Title of Change:	Documentation update for TO-252 Package Case Outline 369C and 369AA
Effective date:	09 Jul 2026
Contact information:	Contact your local onsemi Sales Office
Type of notification:	This Product Bulletin is for notification purposes only. onsemi will proceed with implementation of this change upon publication of this Product Bulletin.
Change Category:	Update note on case outline 369C & 369AA documents.
Change Sub-Category(s):	Datasheet/Product Doc change

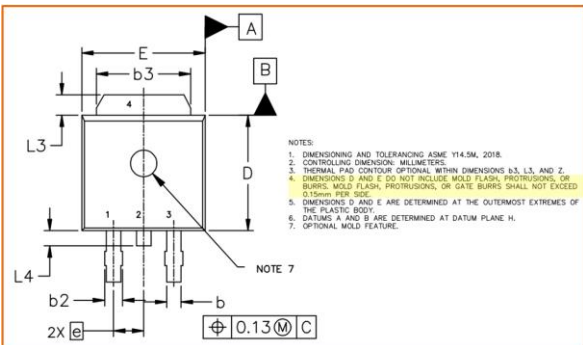
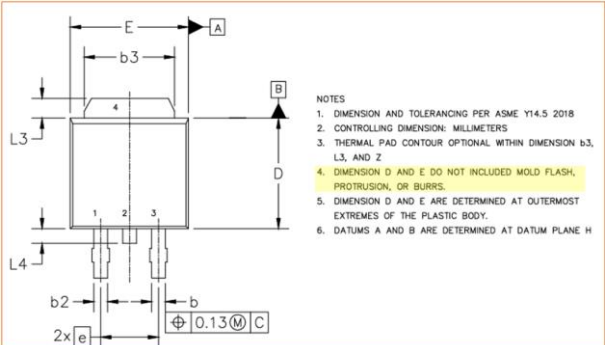
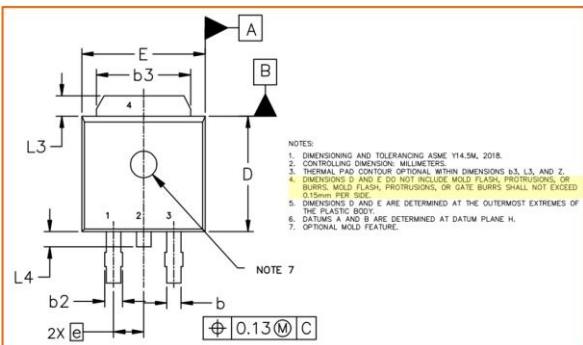
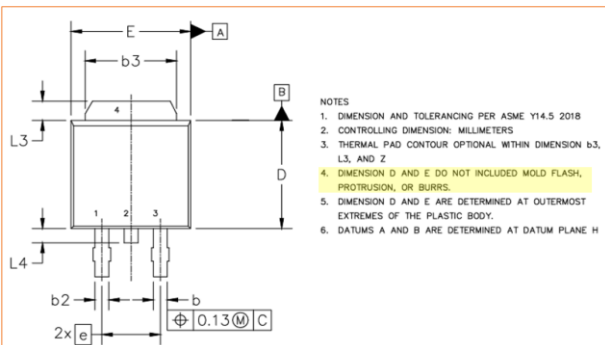
Case Outline	From	To
Case 369C Note	4. DIMENSIONS D AND E DO NOT INCLUDE MOLD FLASH, PROTRUSIONS, OR BURRS. MOLD FLASH, PROTRUSIONS, OR GATE BURRS SHALL NOT EXCEED 0.15mm PER SIDE. 	4. DIMENSIONS D AND E DO NOT INCLUDE MOLD FLASH, PROTRUSIONS, OR BURRS. 
Case 369AA Note	4. DIMENSIONS D AND E DO NOT INCLUDE MOLD FLASH, PROTRUSIONS, OR BURRS. MOLD FLASH, PROTRUSIONS, OR GATE BURRS SHALL NOT EXCEED 0.006 INCHES PER SIDE. 	4. DIMENSION D AND E DO NOT INCLUDED MOLD FLASH, PROTRUSION, OR BURRS.

That's only change on documentation, it's not manufacturing change process.
